MEMORANDUM

SUBJECT: Public Hearing Report for ZC #08-30B
JBG Half Street
Zoning Commission Design Review Under the Capitol Gateway Overlay

2. Variance from Half Street step back requirement (§ 1607.2)

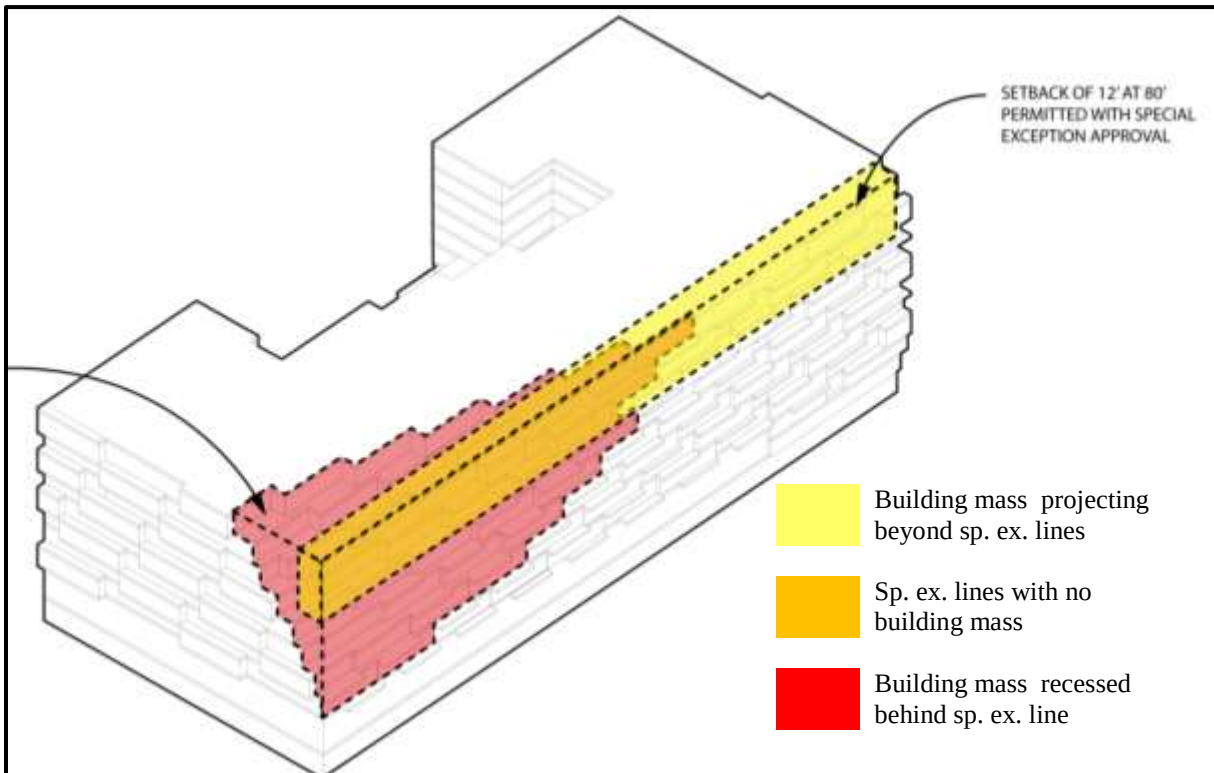
Section 1607.2 requires a 20 foot stepback at 65 feet in height, and permits special exception relief to reduce the stepback to 12 feet at 80 feet in height. The approved application received variance relief to exceed the special exception stepback in certain locations. The current design proposes a building form that recedes away from the south-facing observer on Half Street, using a multitude of cuboid shapes that when coalesced form a sloping surface. At its most prominent, the surface projects forward of the stepback line. Where the building surface is most recessed, at the southern end of the structure, it is well behind the stepback line. The applicant provided OP with the following graphic, which attempts to illustrate the relationship of the building mass to the special exception stepback lines.

OP has no objection to the requested relief. The subject site is unique in that it occupies a prominent location outside of and visible from the interior of the baseball stadium. While not all buildings should be sculptural in form, this location is appropriate for a strong architectural expression. The intent of the regulation – to allow adequate light and air on Half Street and create a pedestrian-scaled environment – would not be impaired. The proposed building form would allow extra light into Half Street by opening up the southern exposure of the street. And while the building would recede from the street, it still would still provide appropriate enclosure with a streetwall up to almost 40 feet at the corner of N and Half.
